Title of Change:	Case outline 340CU (98AON13773G) dimension tightening per industrial standards.
Effective date:	17 Jun 2021
Contact information:	Contact your local ON Semiconductor Sales Office or Yoichi.Hoshina@onsemi.com
Type of notification:	This Product Bulletin is for notification purposes only. ON Semiconductor will proceed with implementation of this change upon publication of this Product Bulletin.
Change Category:	Assembly Change
Change Sub-Category(s):	Product specific change

PCN#: PB24109Z
Issue Date: Jun 17, 2021

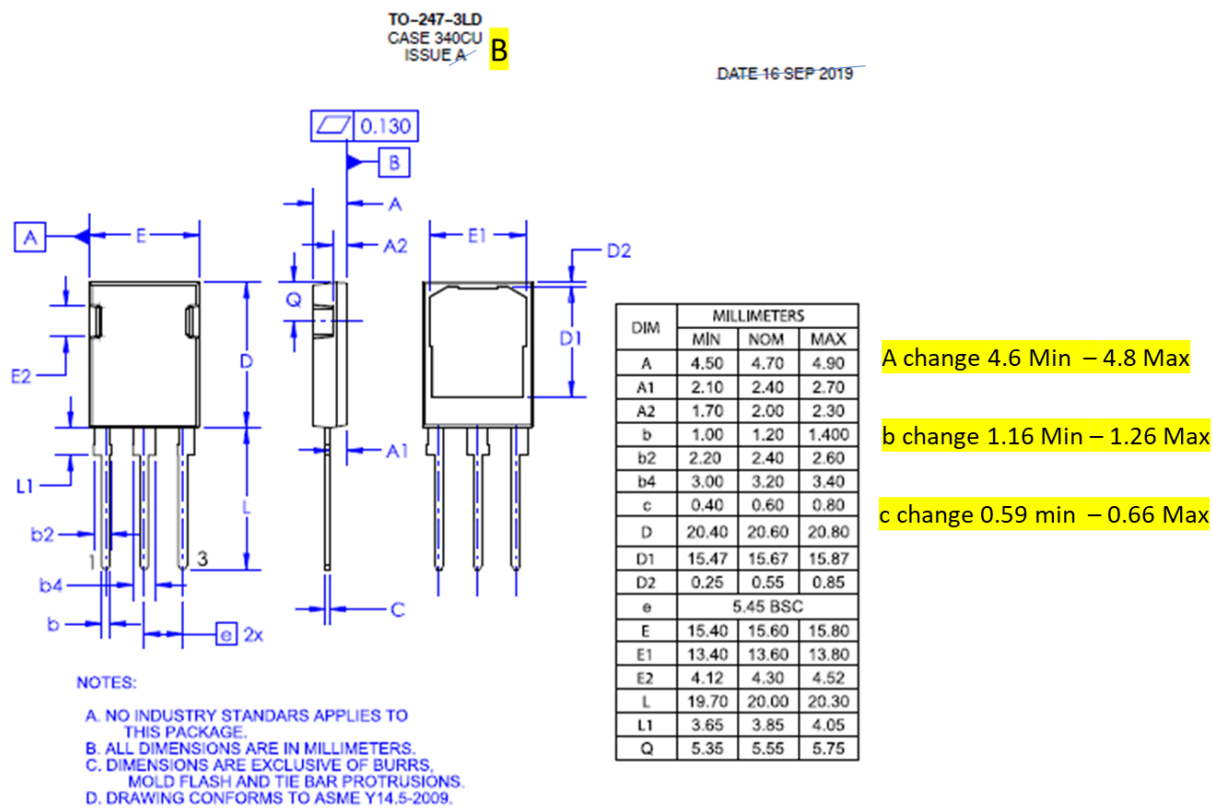
Tightening dimension measurement limit only
